## CVS 43600 Gen-Mar SP 10-33

### **CVS 43600 GEN-MAR SITE PLAN NO. 10-33**

**Planning Review**  
CVS 43600 Gen-Mar  
SP 10-33

**SUBJECT: CVS Office & Parking Expansion, 43600 Gen Mar,  
Preliminary Site Plan, SP#10-33, Traffic Review**

Attachment: Aerial photo

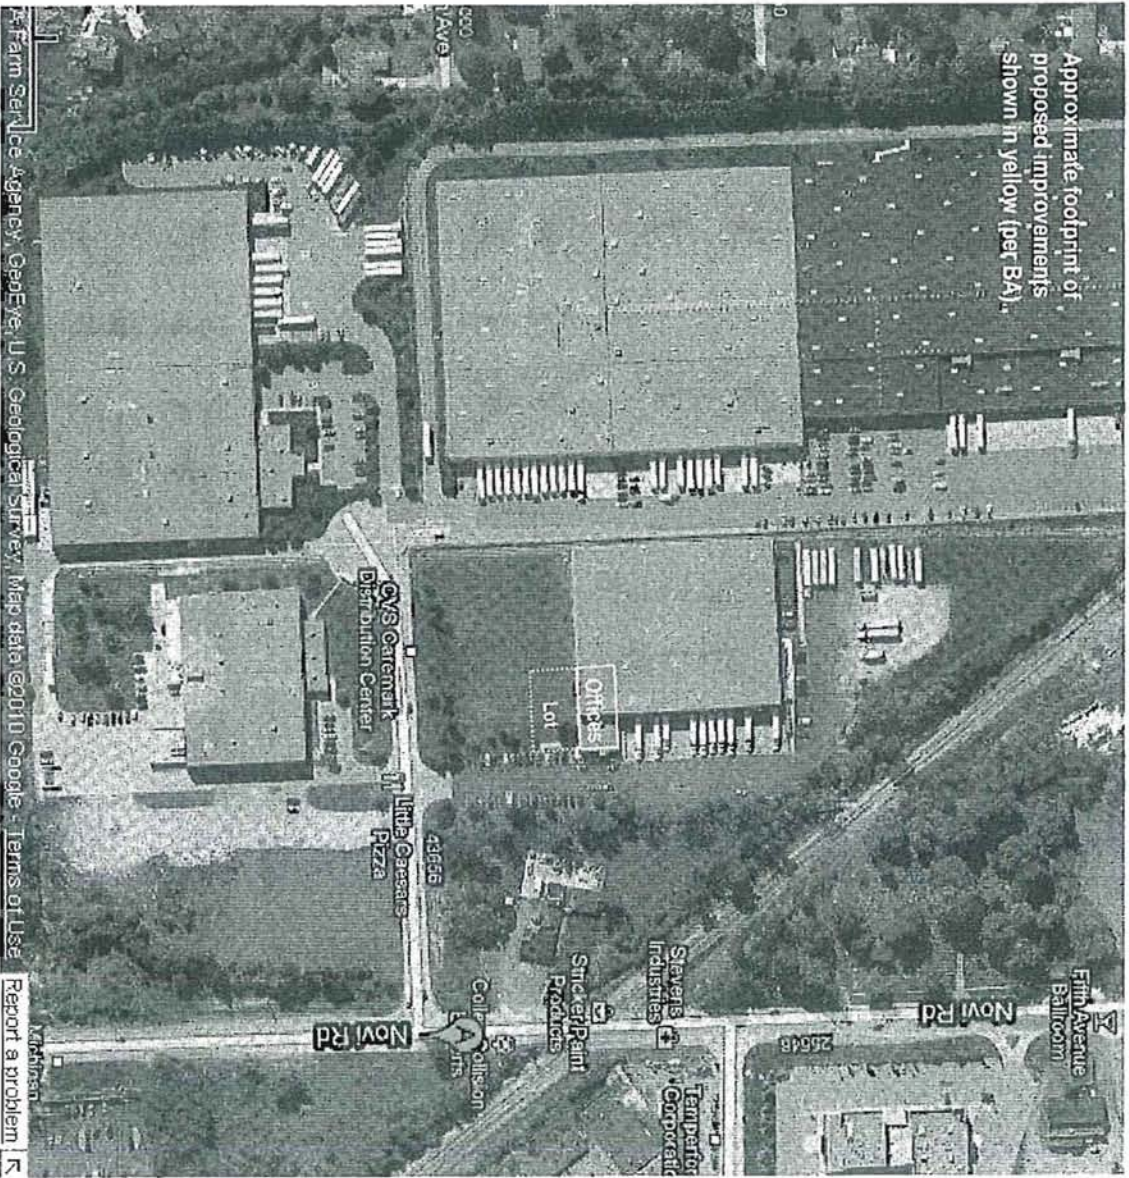
1. The applicant, CVS Pharmacy, proposes to construct a new office building at the southeast corner of the existing building. Per the attached aerial photo, the facility would occupy the footprint of the existing office wing, plus a portion of the existing main (warehouse) building. A new, 24-space parking lot would be built south of the office facility and parking spaces in the existing lot to the east would be reconfigured.
2. North of the warehouse, the applicant proposes to (a) re-stripe existing parking spaces adjacent to the building, and (b) land-bank a possible future parking lot extension containing 16 spaces. **The applicant should be asked to comment on the fact that the attached aerial photo shows areas containing both existing and possible future striped parking spaces being used for semi-trailer parking instead of typical passenger-sized vehicles.**

1. The applicant should be asked to comment on the fact that the attached aerial photo shows areas containing both existing and possible future striped parking spaces being used for semi-trailer parking instead of typical passenger-sized vehicles.

*The existing photo shows semi-trailer parking north of the existing building. This aerial is older and does not appear consistent with the currently striped passenger-sized vehicle parking. At this time, we are not aware at this time of any deviations from the current vehicle striping.*
